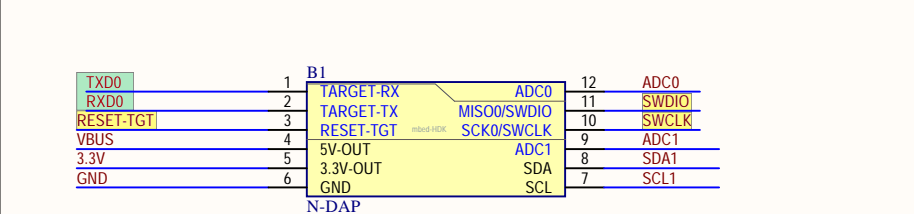
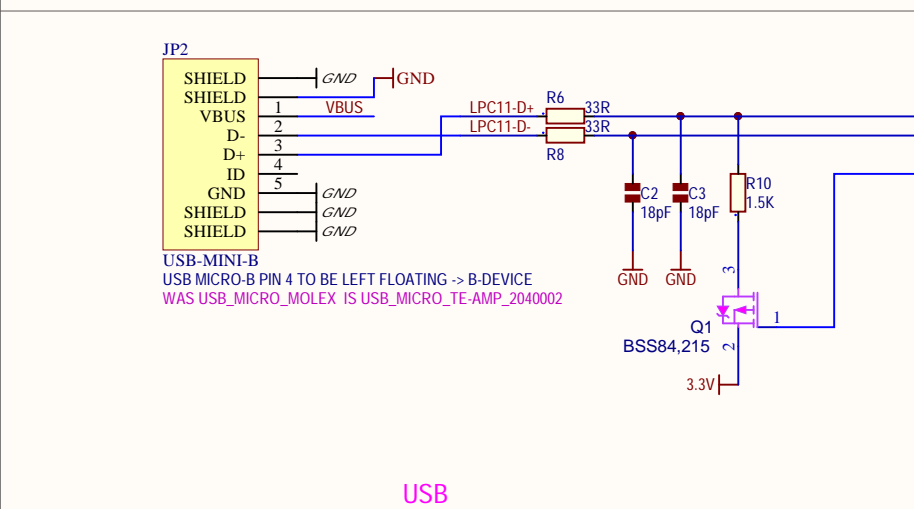
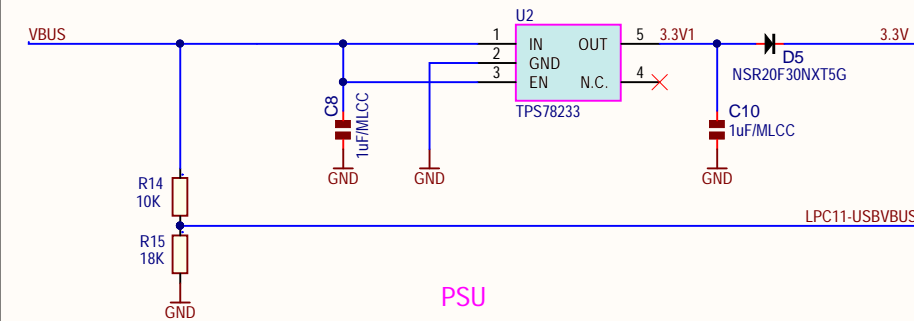
TODD:
TEST IF R9 FIXES THE "ALWAYS TO ISP AFTER RESET" ISSUE
BY SOLDERING A 10K PULL-UP
